THE VERANDAH

ADMINISTRATIVE AMENDMENT REQUESTS

REQUEST SUMMARY
ADD2018-00062 -MODIFICATIONS

GRADING AND DRAINAGE PLAN

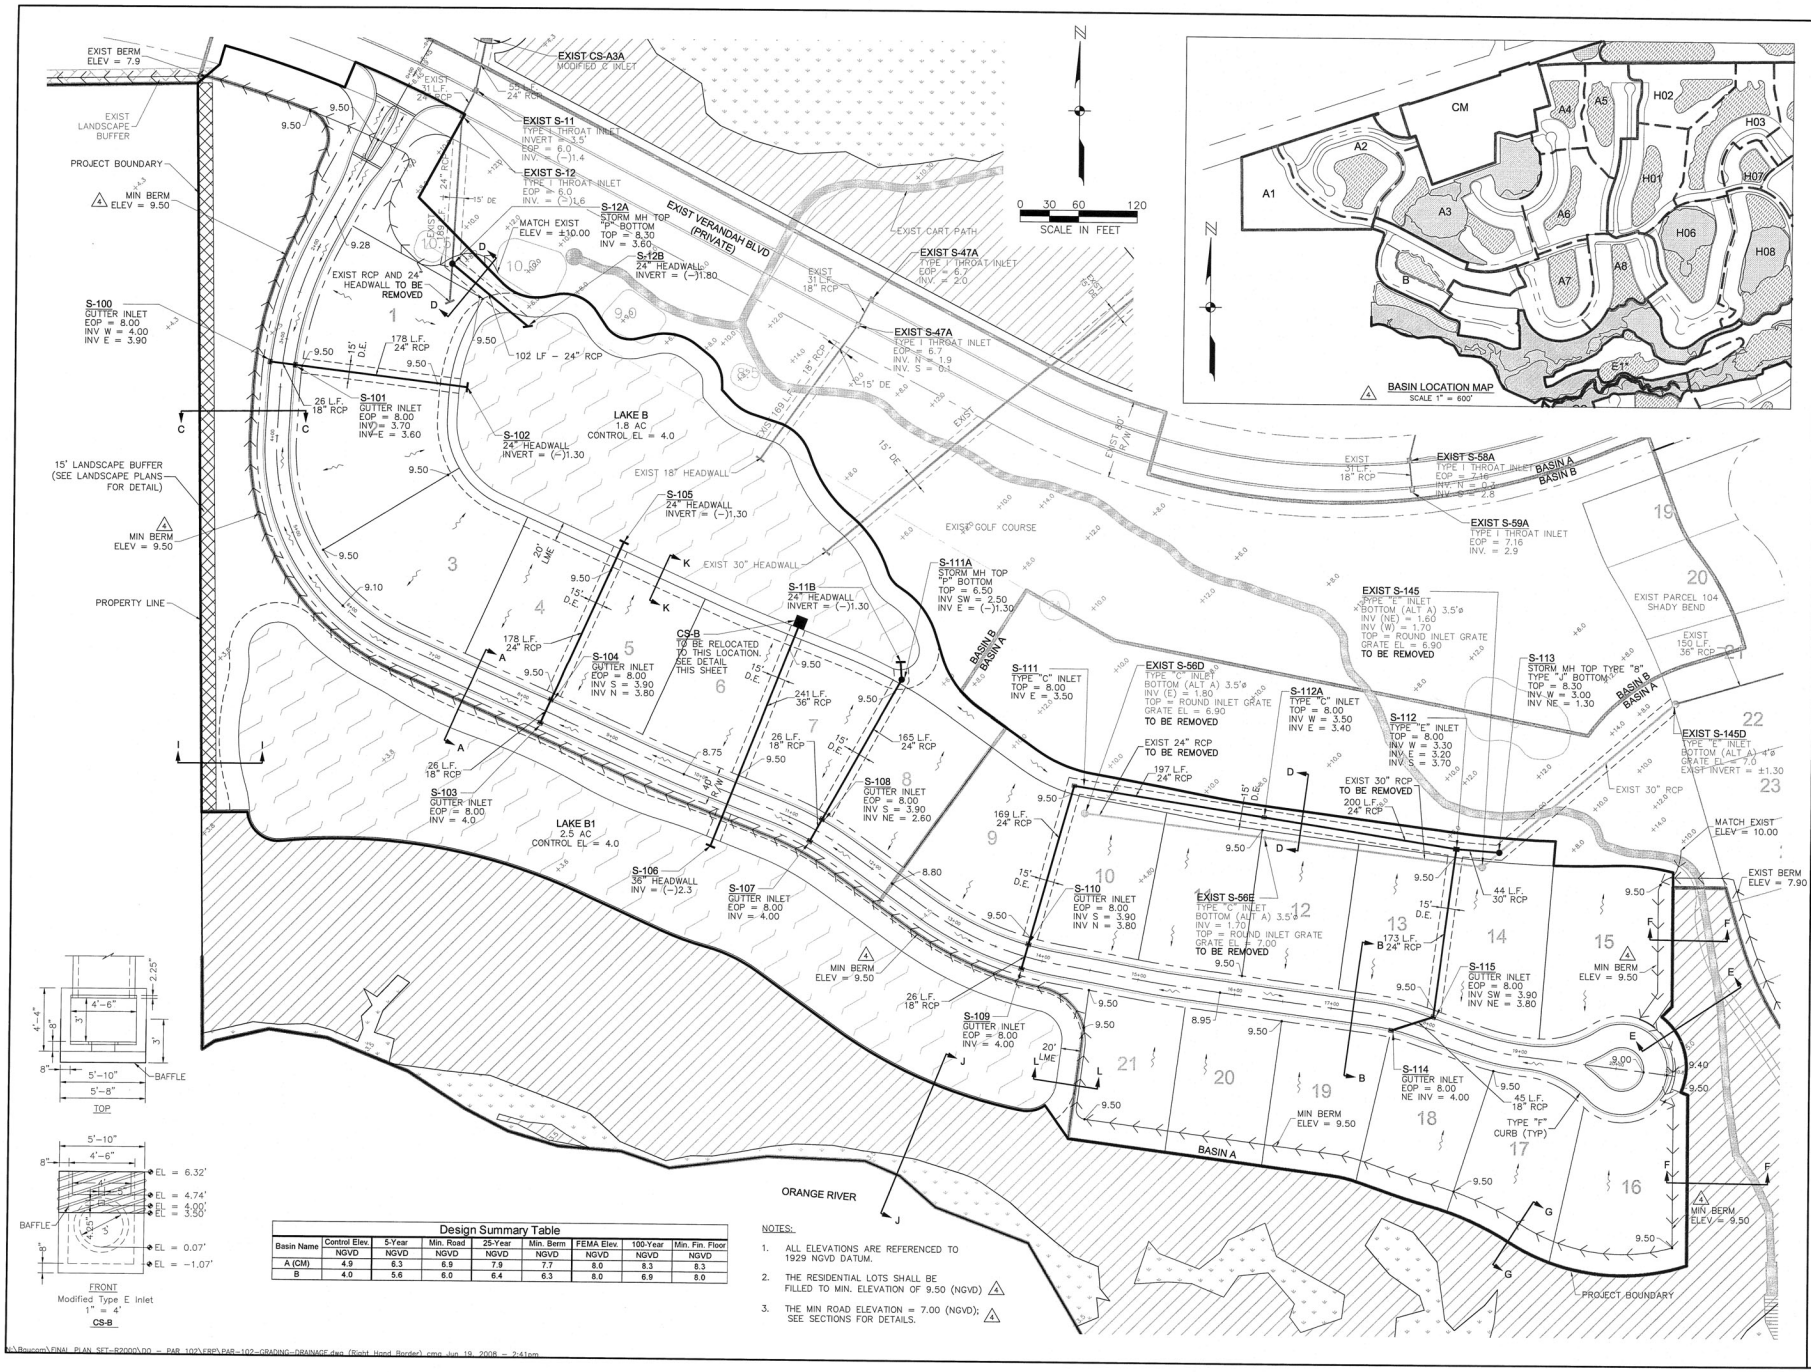
2) Applicant is requesting to modify Deviation 5 approved under ADD2018-00062 by removing "Lake B1" from this approved Deviation. This lake is strictly used for conveyance, not for surface water quality or quantity. The littoral enhancements are not required since the 4:1 lake bank slope was previously approved by ADD2008-00028.

South Florida Water Management District Permit 36-04314-P/Application 070511-25 is silent regarding Lake B1. The plans show no littoral shelves and all lake banks are 4:1. Lake B1 is shown with a Control Elevation of 4.0, but nothing is controlling the lake.

Stormwater runoff associated with the 6.34 acre controlled basin Area of subbasin A is discharging into Lake A7 and stormwater runoff associated with the 7.32 acre controlled basin area of subbasin B is discharging into Lake B. Both lakes are part of the Verandah master surface water management system, which provides the water quality and attenuation requirements

App 030124-5 removed lake B1, and the residential lots and roadway north of the Lake within Basin B by relocating the perimeter berm. "… Lake B1 was located outside the surface water management system and provided additional conveyance for the Orange River to insure no change in the staging of the river between the pre-development and post-development conditions. The plans now identify this area as future development with only exotic removal and limited clearing of the understory.

Revised modeling of the Orange River system shows that the removal of the proposed residential improvements off-set the removal of Lake B1 from the conveyance of the Orange River. Therefore, with the limited vegetation removal in this area, sufficient conveyance is provided in the Orange River so that the change in the staging between the pre-development and post-development condition is less than 0.1 ft increase. This is consistent with the originally approved design.
